December 1, 2011

Jon Taylor, PE CEM
Nevada Division of Environmental Protection
Bureau of Waste Management
901 S. Stewart St., Suite 4001
Carson City, NV 90701-5249

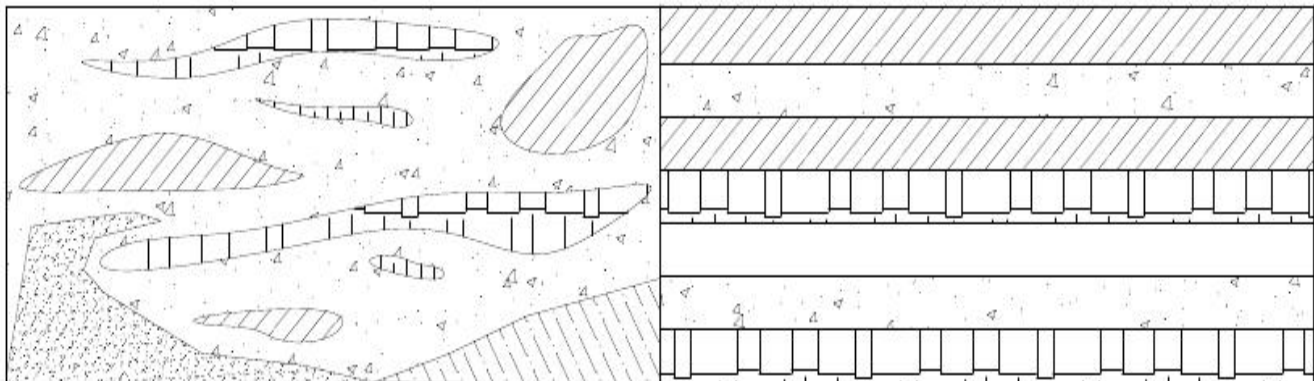
The graphic below is indicative of how Golder, throughout the permit application materials, manipulated the data. Berger in his USGS Water-Resources Report 95-41 19 (page 20) states, "In general, the basin fill deposits within the study area consists of discontinuous units and heterogeneous mixtures of gravel, sand, silt and clay and, as such, function as a single aquifer system" (represented by the left graphic). By extrapolating the borehole data over thousands of feet horizontally (represented by the right graphic) Golder presents a picture of a perfectly stratified subsurface structure that Berger expressly refutes.

By depicting a tightly structured soil stratigraphy, Golder can claim subsurface stability for construction and at the same time, if there is any failure of structural integrity of the landfill cells, can also claim a delineated natural barrier of clay layers to prevent aquifer contamination. Metaphorically, in the Jungo landfill application materials, Golder has been engaged in the practice of putting lipstick on a pig.
